**ADDENDUM to TECHNICAL DRAINAGE STUDY
FOR
824 South Decatur Blvd.
(Update for Goal Extended Stay)**

**JOB NO. 210261
September 2022**

3rd Submittal: Update #1

**Subject: Addendum to Technical Drainage Study for 824 South Decatur Boulevard (Update for
Goal Extended Stay)
CLV #DS4956C**

GRADING PLAN

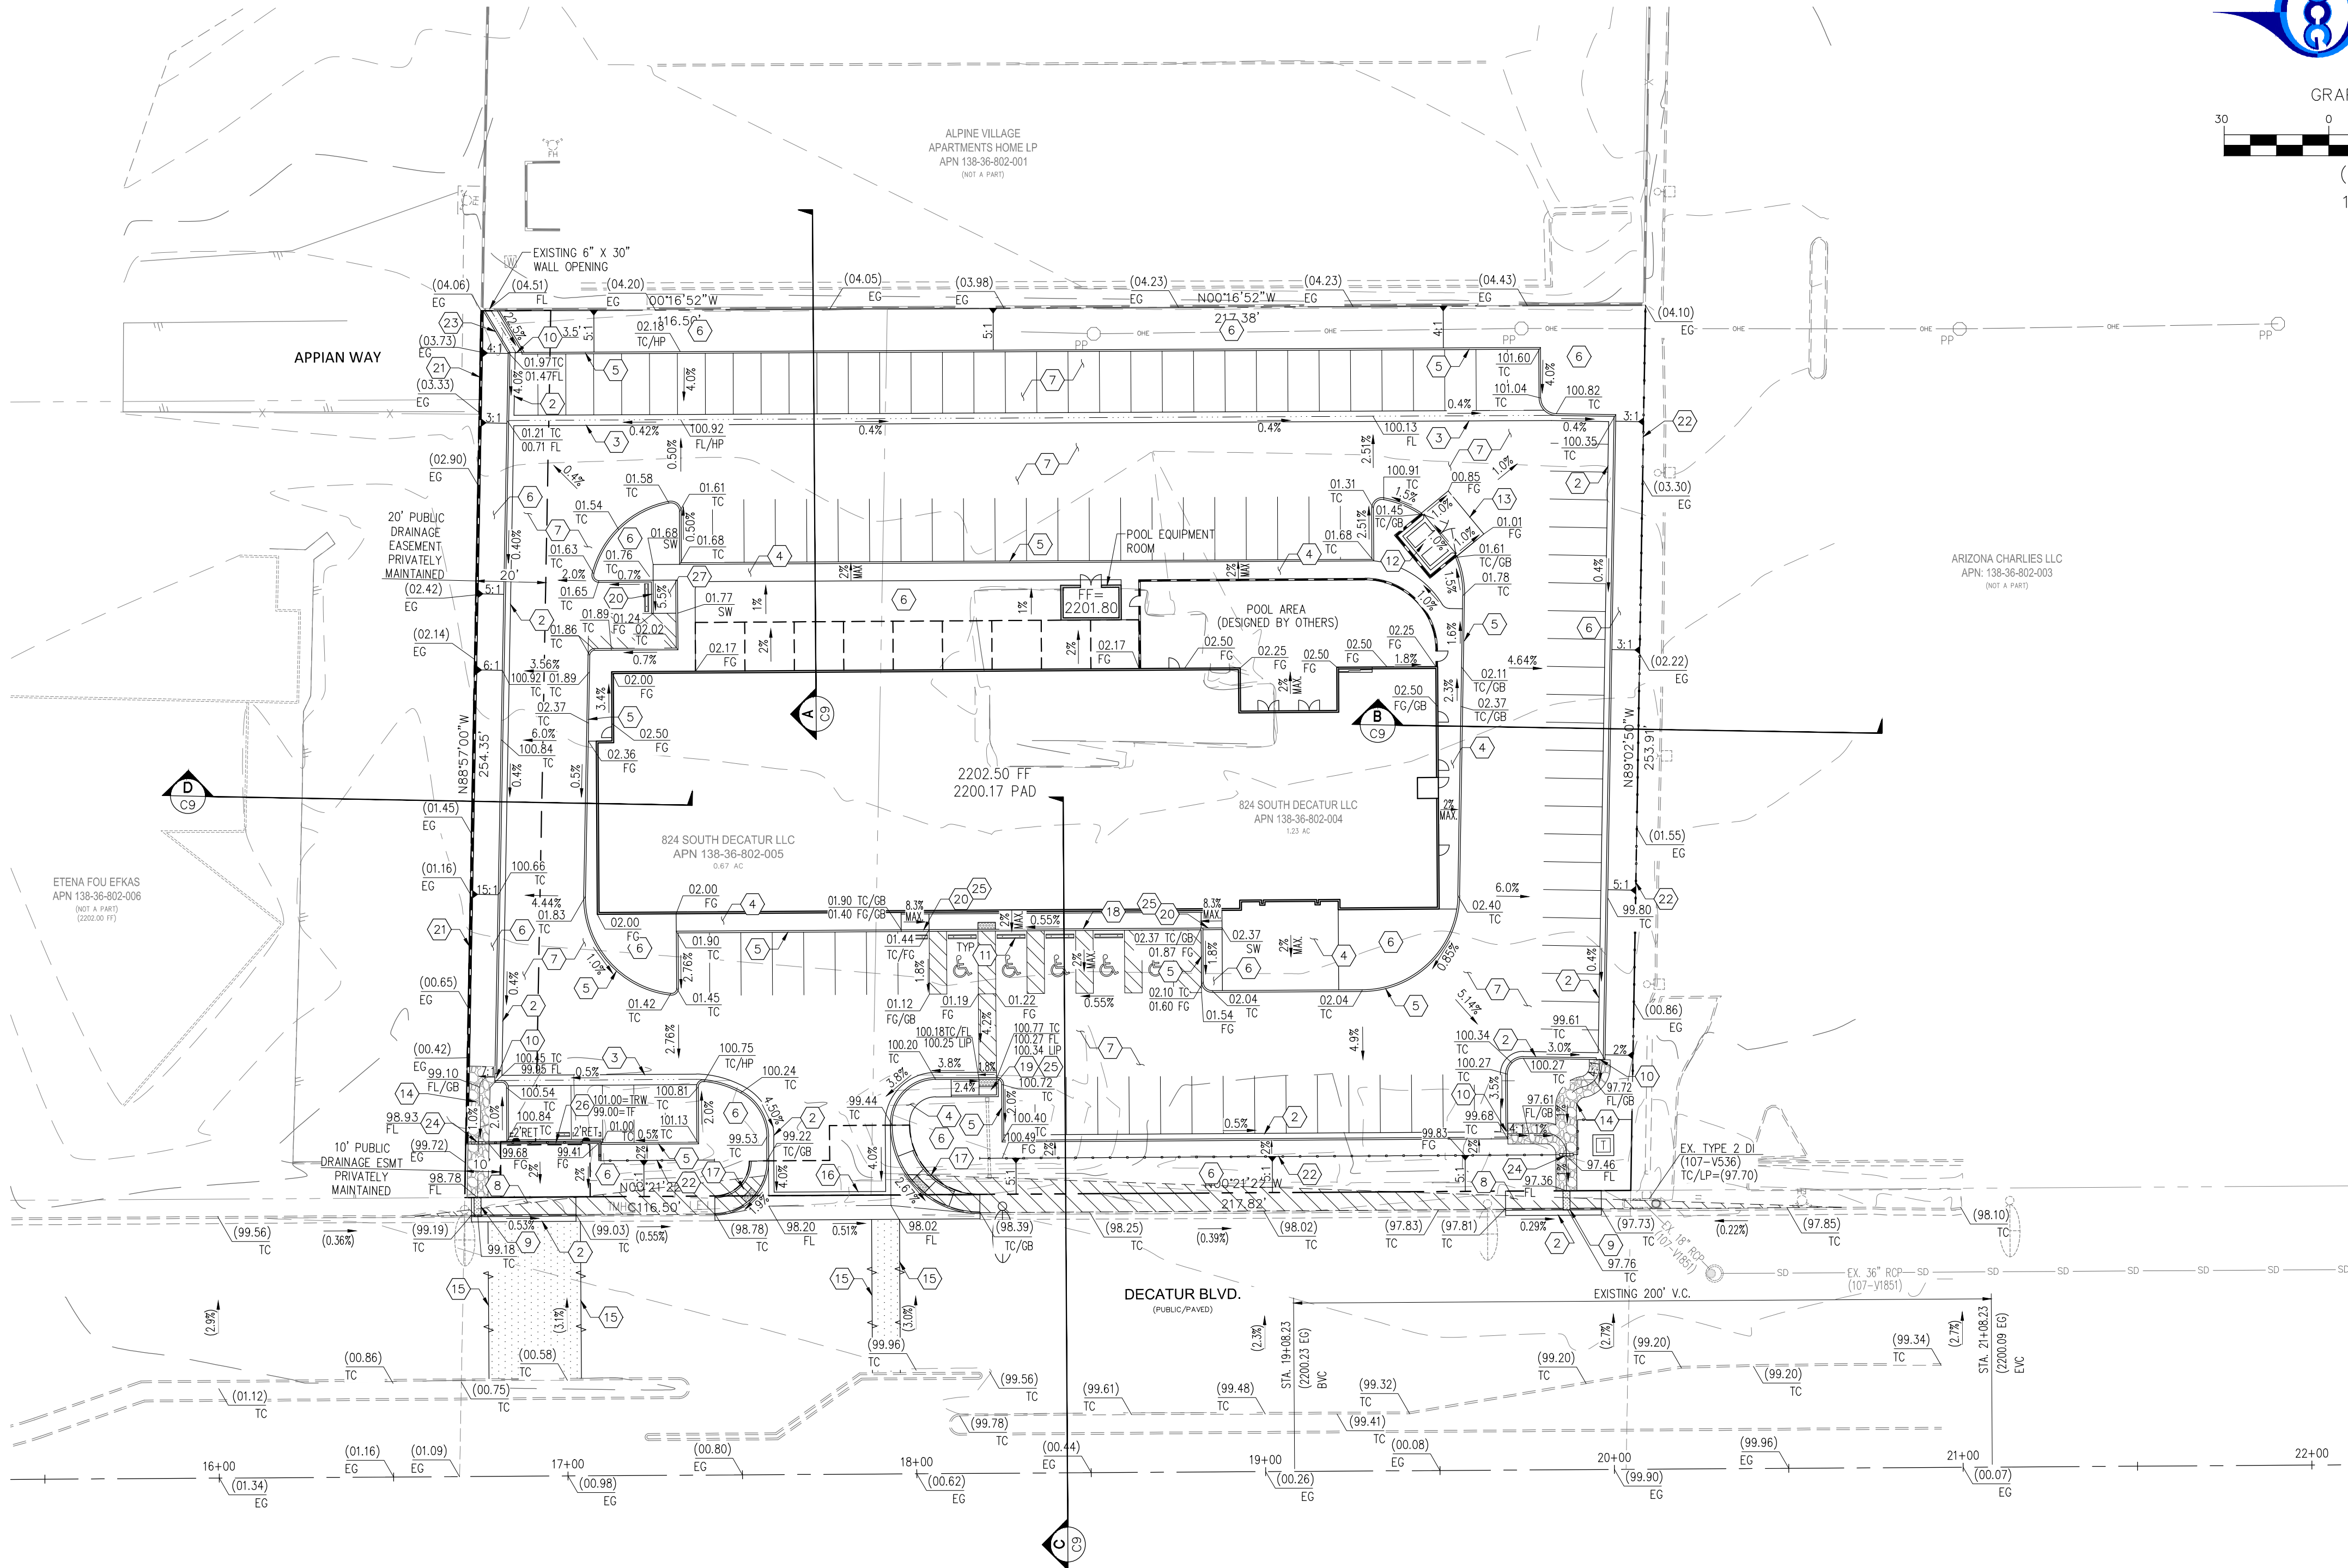
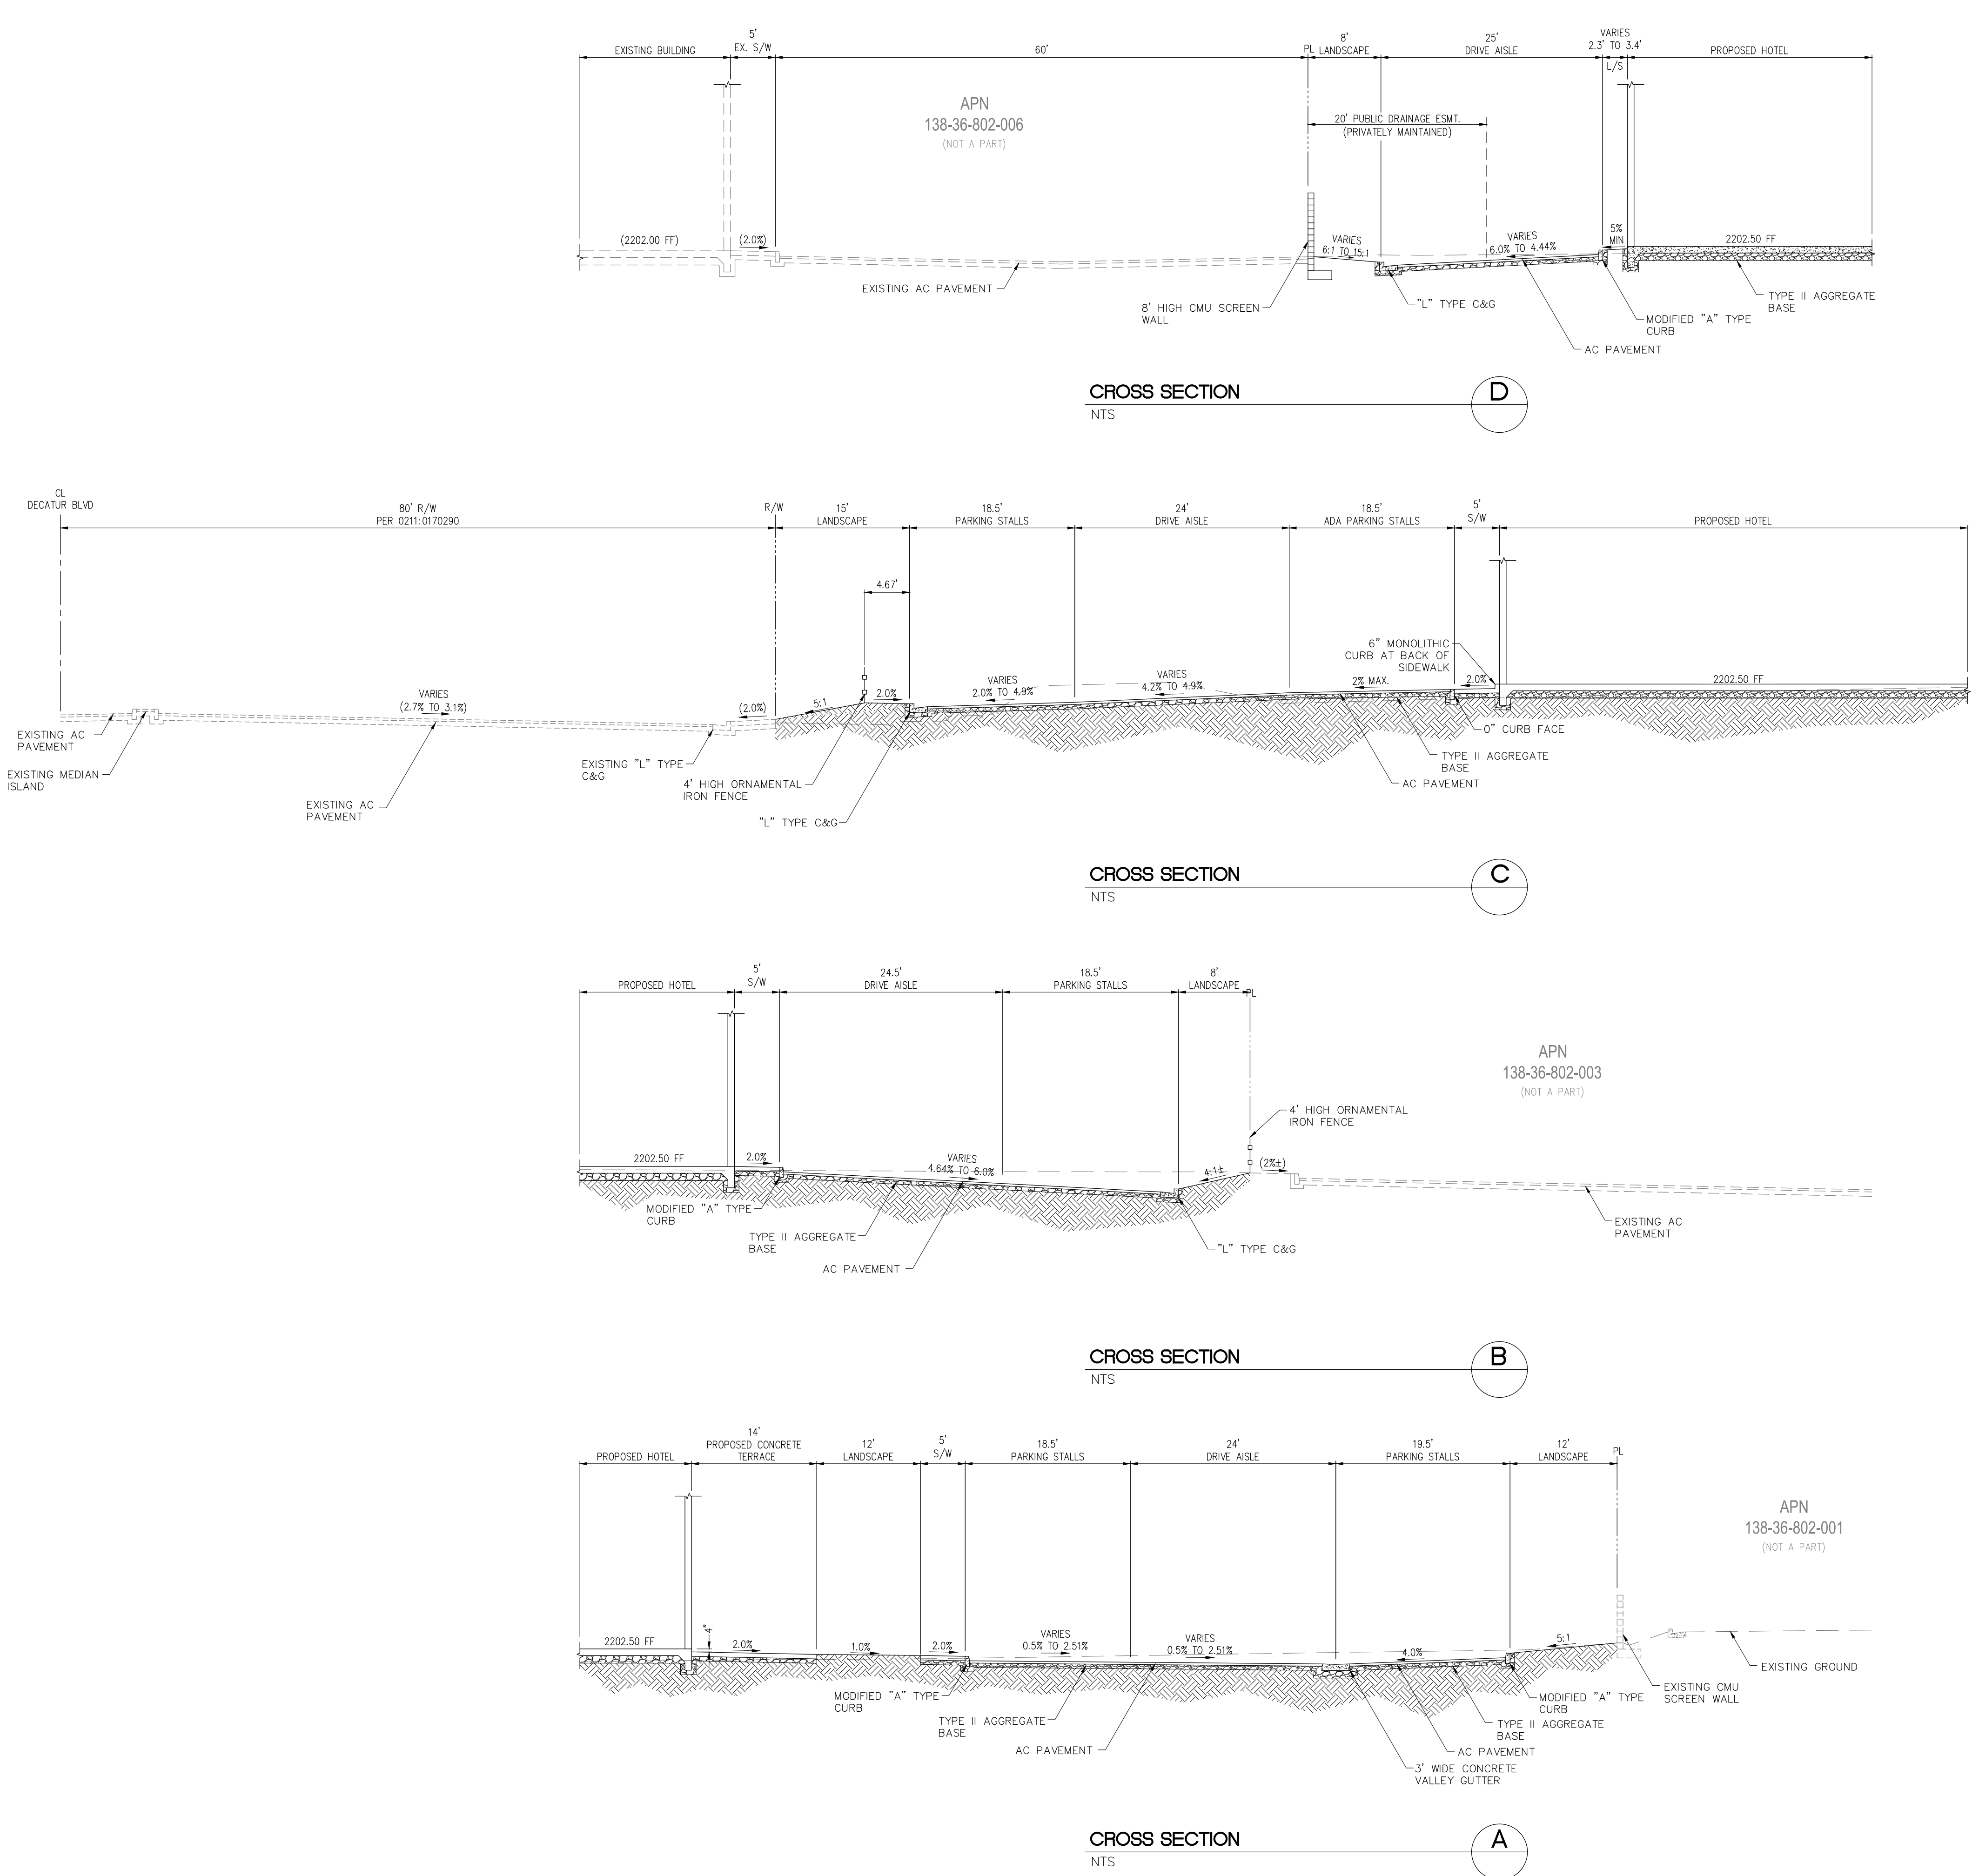
5. Label an existing storm drain in *Decatur Boulevard* with *City of Las Vegas* recorded drawing number on the grading plan. Identify all drop inlets and laterals with type and size information.
6. Provide current "Stormwater Management Notes" on the General Notes Plan.
7. Provide a note on all grading plans (Standard Note No. 6): Post-Construction BMPs (PCBMPs) / Control Measures noted on the Grading Plans are mandatory permanent regulatory stormwater pollution controls. These PCBMPs must be installed per the approved plans and must be permanently maintained.

5. Label an existing storm drain in Decatur Boulevard with City of Las Vegas recorded drawing number on the grading plan. Identify all drop inlets and laterals with type and size information.

7. Provide a note on all grading plans (Standard Note No. 6): Post-Construction BMPs (PCBMPs)/Control Measures noted on the Grading Plans are mandatory permanent regulatory storm water pollution controls. These PCBMPs must be installed per the approved plans and must be permanently maintained.

Response: Noted.

Response: Noted.

POST-CONSTRUCTION BMPs (PGBMPs) / CONTROL MEASURES NOTED ON THE GRADING PLANS ARE MANDATORY PERMANENT REGULATORY STORMWATER POLLUTION CONTROLS. THESE PGBMPs MUST BE INSTALLED PER THE APPROVED PLANS AND MUST BE PERMANENTLY MAINTAINED.
